MIDDLE OCONEE RAW WATER STATION

CITY OF ATHENS
ATHENS, GEORGIA

JOB NO. 800024

ATHENS, GA
RAW WATER STA.
#800024
C.O. #3 7-11-83
DS: EX 7

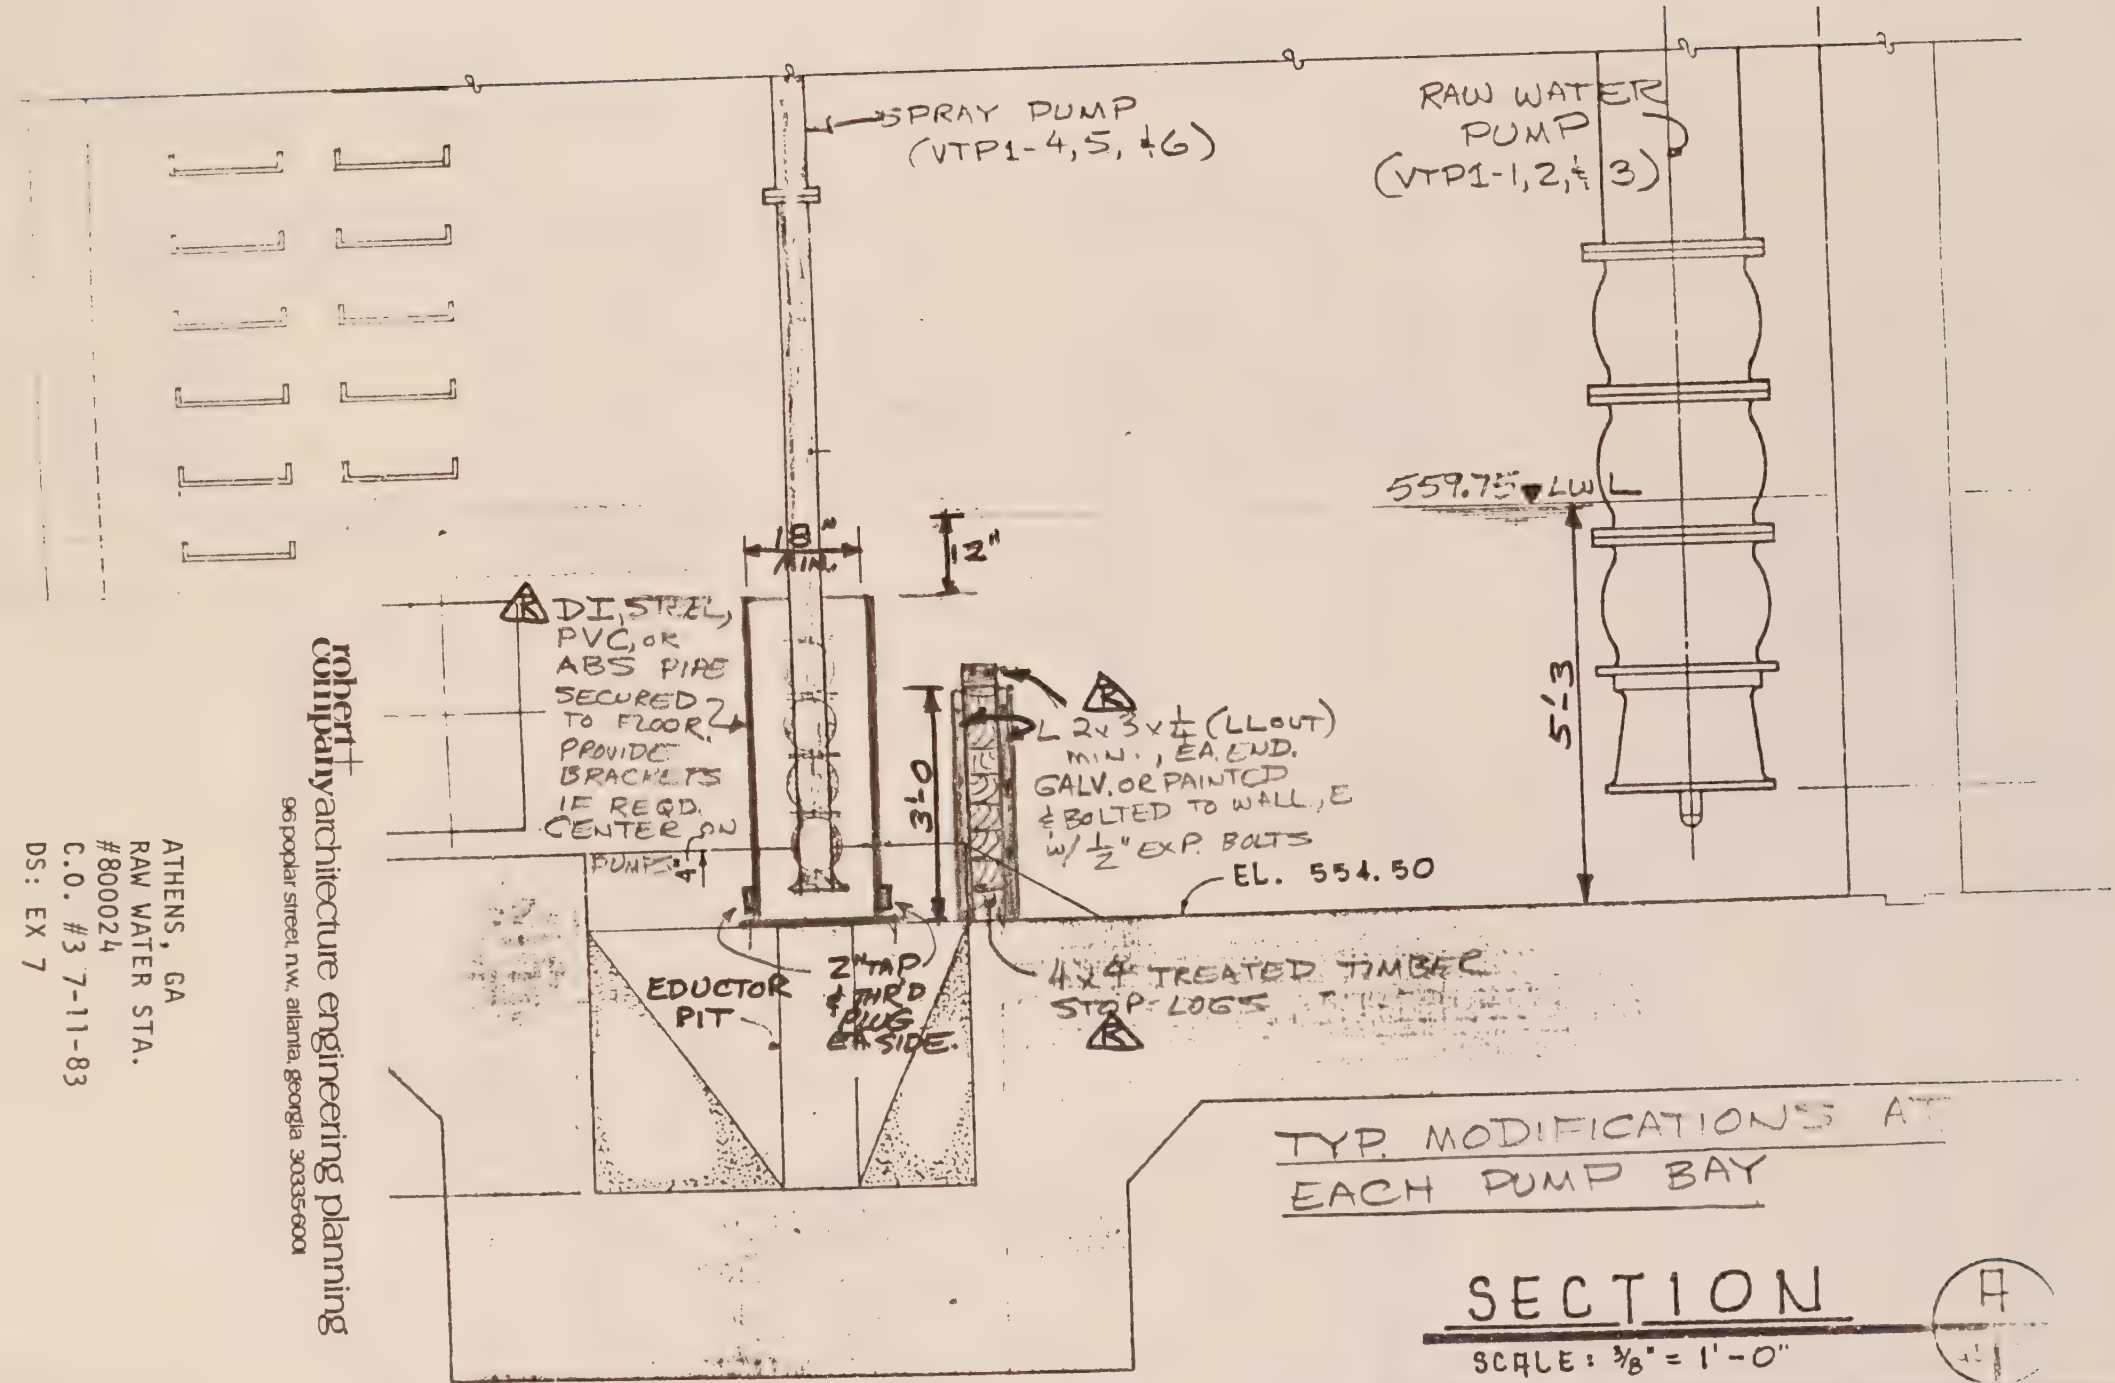
SPRAY PUMP (VTP1-4,5,&6)
RAW WATER PUMP (VTP1-1,2,& 3)
559.75 LWL
18" MIN.
12"
DI, STEEL, PVC, OR ABS PIPE SECURED TO FLOOR. PROVIDE BRACKETS IF REQD.
CENTER ON PUMP
3'-0
L 2x3x1/4 (LLOUT) MIN., EA. END. GALV. OR PAINTED & BOLTED TO WALL, E w/ 1/2" EXP. BOLTS
5'-3
EL. 551.50
EDUCTOR PIT
2" TAP & THRD & PLUG EA SIDE.
4x4 TREATED TIMBER STOP-LOGS
TYP. MODIFICATIONS AT EACH PUMP BAY
SECTION
SCALE: 3/8" = 1'-0"
A

ATHENS, GA
RAW WATER STA.
#800024
C.O. #3 7-11-83
DS: EX 8

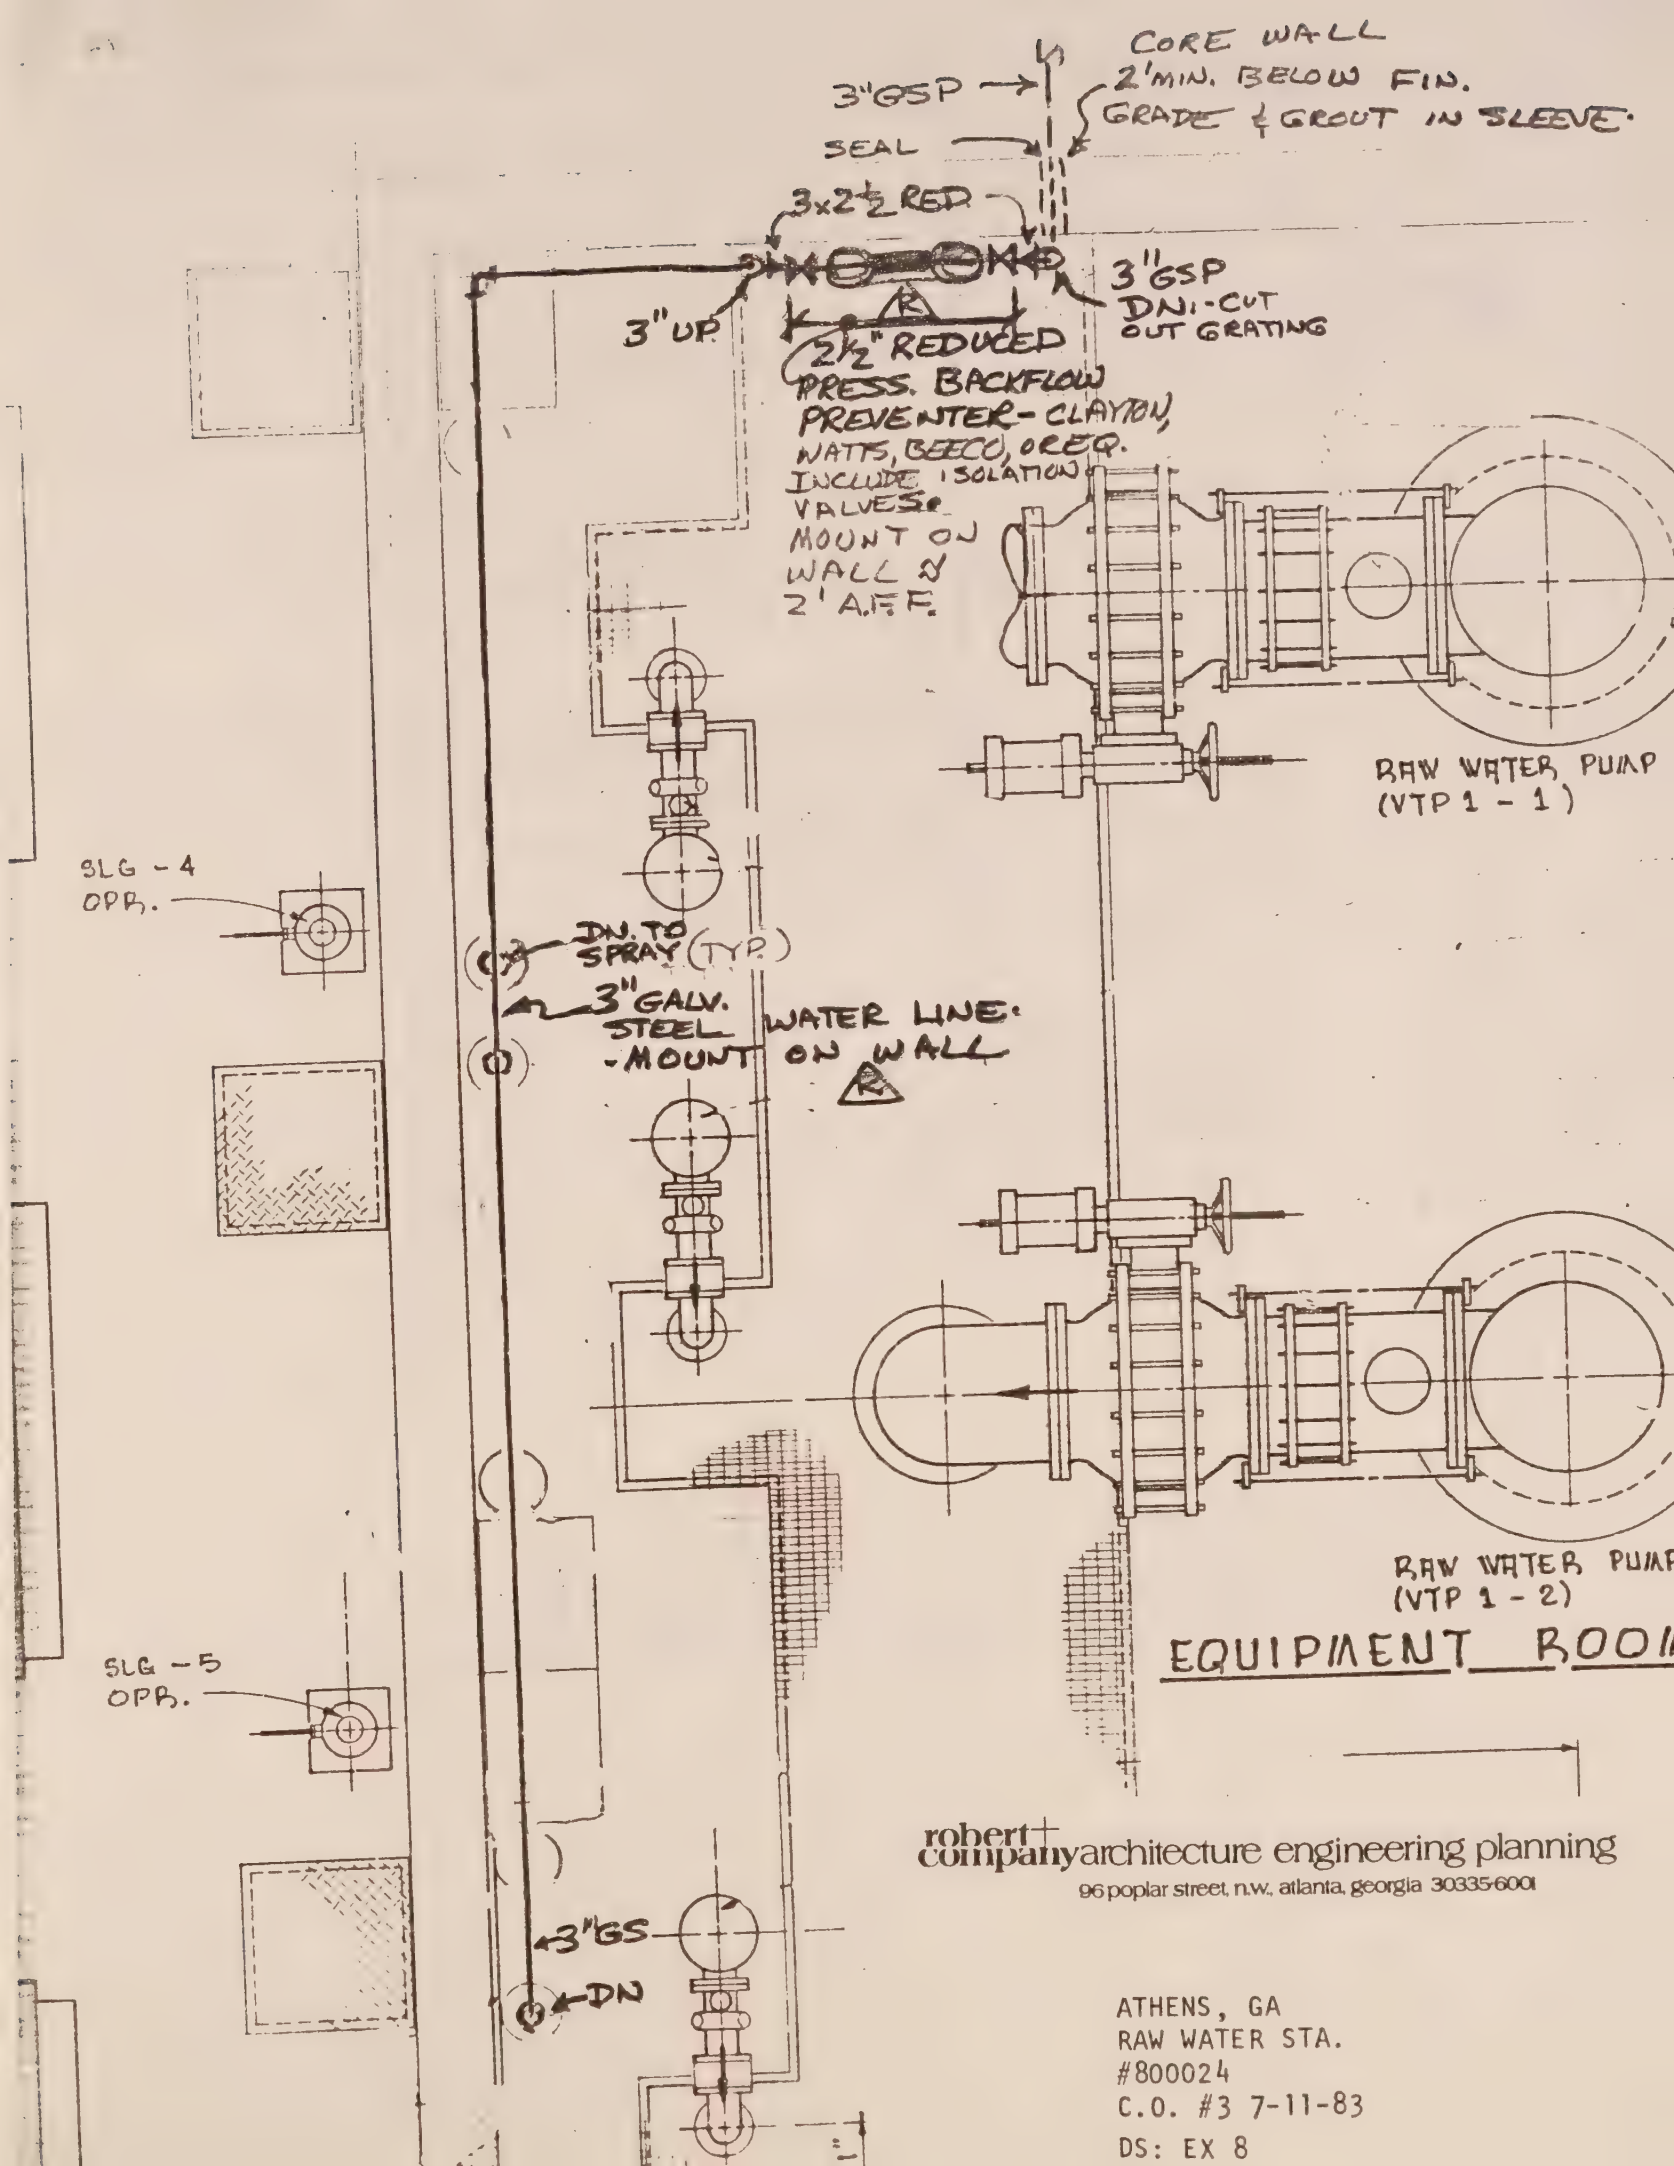
CORE WALL
2' MIN. BELOW FIN. GRADE & GROUT IN SLEEVE.
3" GSP
SEAL
3x2½ RED
3" GSP DN.-CUT OUT GRATING
3" UP
2½" REDUCED
PRESS. BACKFLOW PREVENTER - CLAYTON, NATTS, BEECO, OREQ. INCLUDE ISOLATION VALVES. MOUNT ON WALL @ 2' A.F.F.
RAW WATER PUMP (VTP 1 - 1)
SLG - 4 OPR.
DN. TO SPRAY (TYP.)
3" GALV. STEEL - MOUNT
WATER LINE ON WALL
RAW WATER PUMP (VTP 1 - 2)
EQUIPMENT ROOM
SLG - 5 OPR.
3" GS
DN

TYPICAL SPRAY AND EDUCTOR MANIFOLD DETAIL

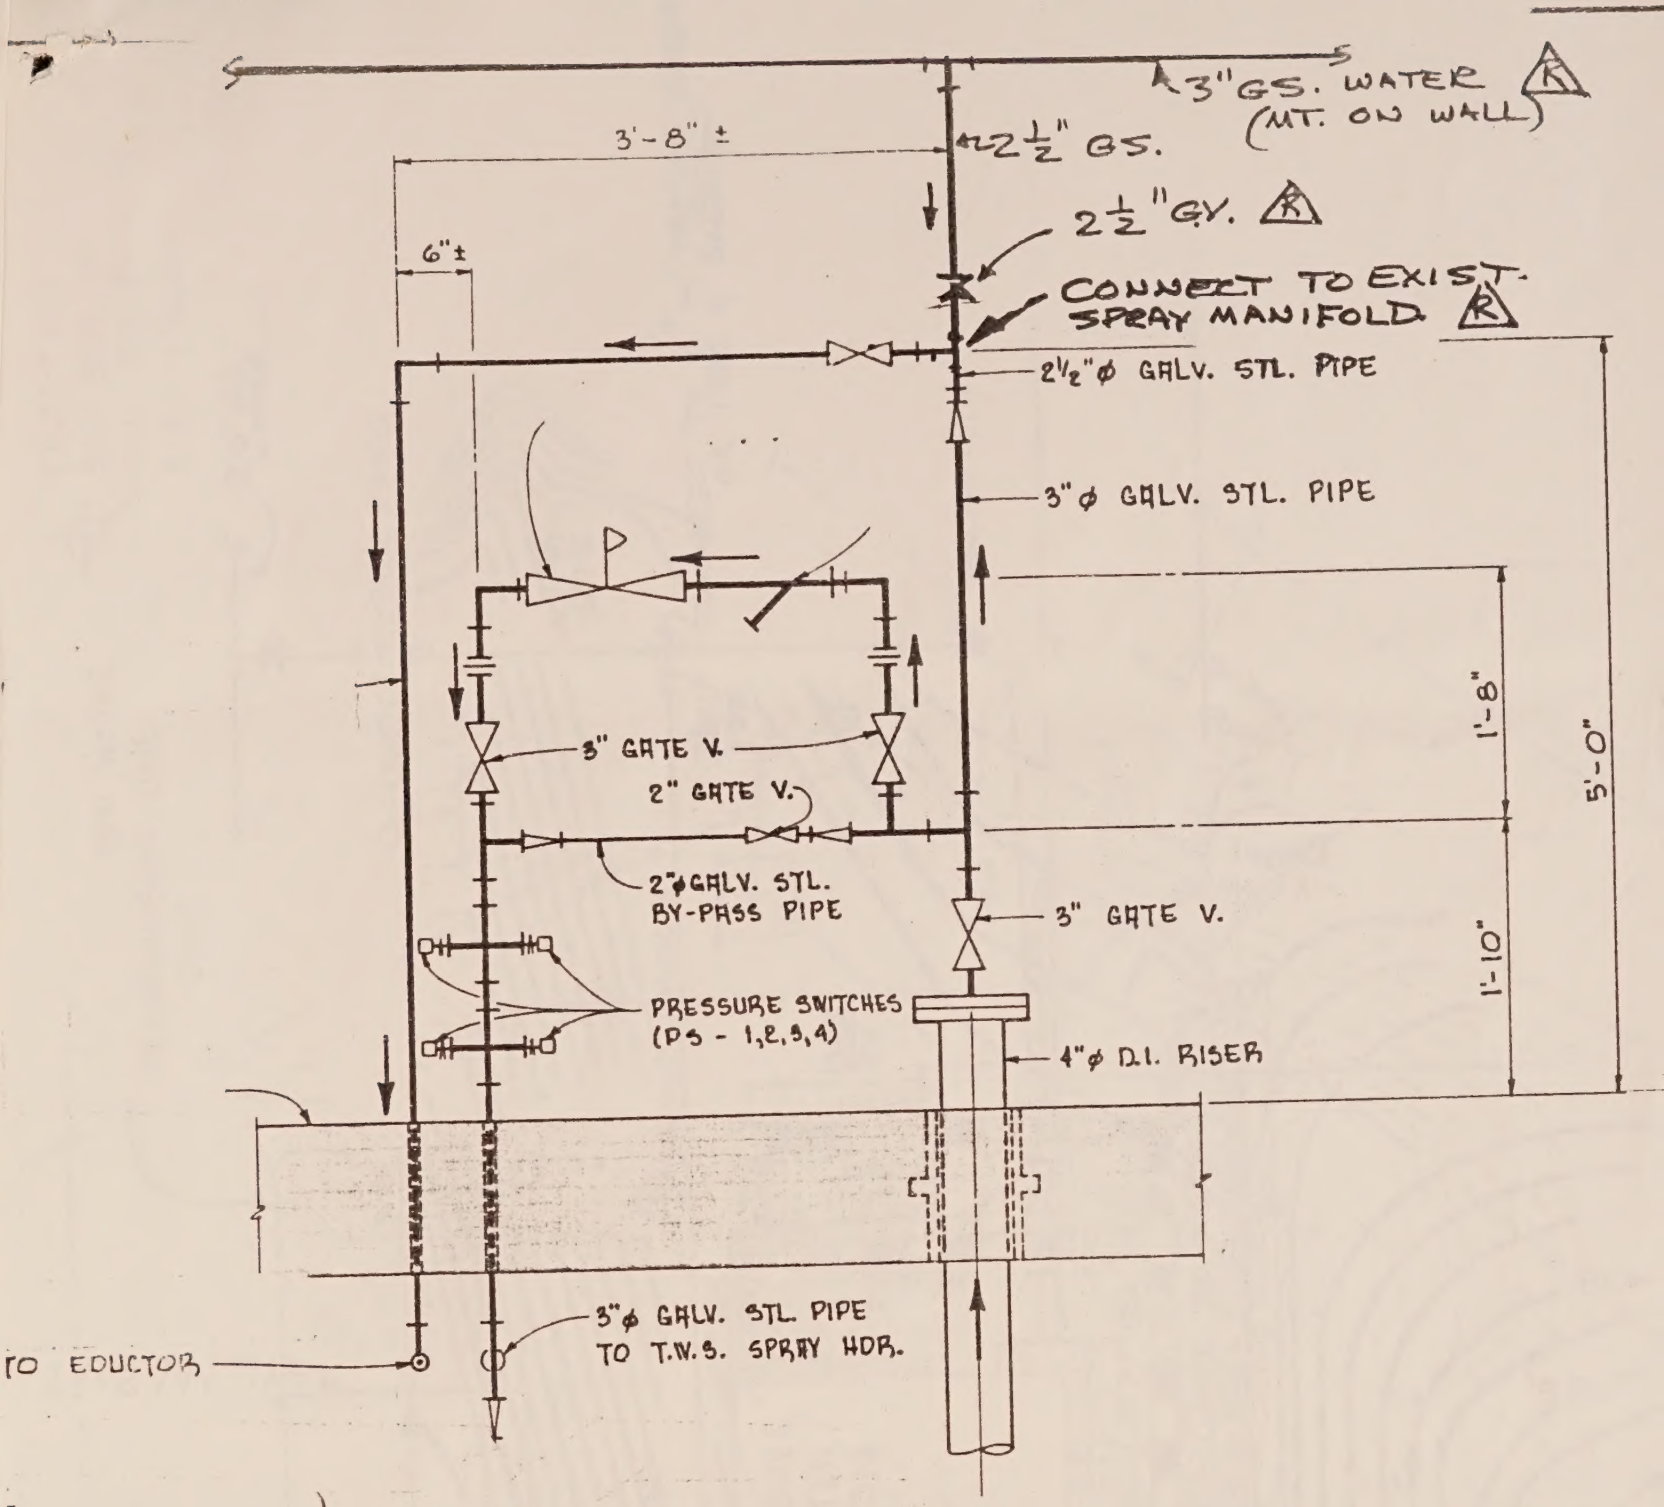
ATHENS, GA
RAW WATER STA.
#800024
C.O. #3 7-11-83
DS: EX 9
